CITY OF ST. PETERSBURG, FLORIDA

STAFF REPORT

Community Planning and Preservation Commission Certificate of Appropriateness Request

22-90200094

Figure 8: Fence example from application

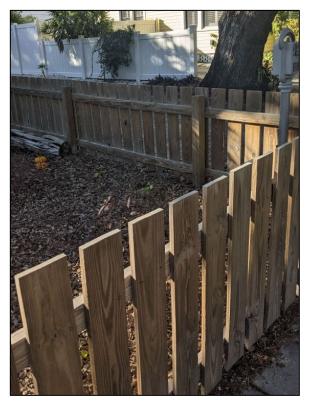
- 3. **Fence:** As discussed in the cases of proposals that have come before this Commission in the recent past, fences were less common during Kenwood's Period of Significance than they are now, and open front

Because a low fence with high transparency will not obscure views of the residence is easily reversible, staff considers the proposal for a front yard fence to be partially consistent with this criterion.

The proposed wood material is noted by St. Petersburg's Design Guidelines for Historic Properties to be among the more appropriate fence materials for use in historic districts, although a rounded, pointed, or scalloped picket is more typical to traditional fences than the flat pickets shown. A painted finish is recommended.

The proposed archway at the entrance to the front yard is not consistent with designs common to the historic period to staff's knowledge. Such garden details were placed to the side or rear of residences and utilized as garden features, when used, rather than as entryways. Staff has concerns that the proposed archway will obscure the architecture of the house.

Staff recommends approval of the general placement of a front fence but suggests that its height be lowered to three feet from grade, a rounded or pointed picket type be used, the archway relocated to the side or rear, and a painted finish be applied.

Staff recommends the height of the picket fence be lowered from four feet to three feet.

Figure 9: Image of typical exterior trim for historic sash windows

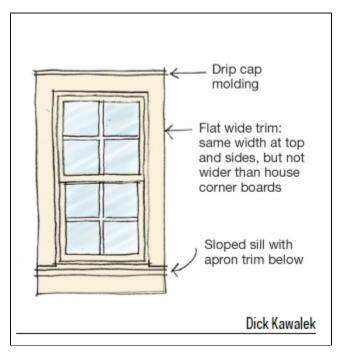
Staff recommends that approval of the replacement window be conditioned upon a required setback of approximately two inches in the wall plane and feature a traditional trim configuration. Since the windows at the primary residence do not feature apron trim beneath their sills, staff recommends that this trim include a drip cap, side trim boards, and sill trim. Since the historic wood siding at this accessory building has been approved for replacement with cementitious fiberboard, staff finds the use of either material for the window trim to be appropriate.

- 1. Window will be installed to be setback within the wall plane and feature a reveal of at least two inches, to match the historic window reveal.
- 2. Window will feature external, three-dimensional contoured grilles to replicate traditional muntins, and the muntin pattern will replicate the two-over-two horizontal oriented configuration as depicted in the application and this staff report.
- 3. Window will feature traditional trim for historic sash windows including a drip cap, side trim boards, and a sloped sill.
- 4. The fence's height will be approximately three feet from grade.
- 5. The fence will feature a rounded or pointed picket type
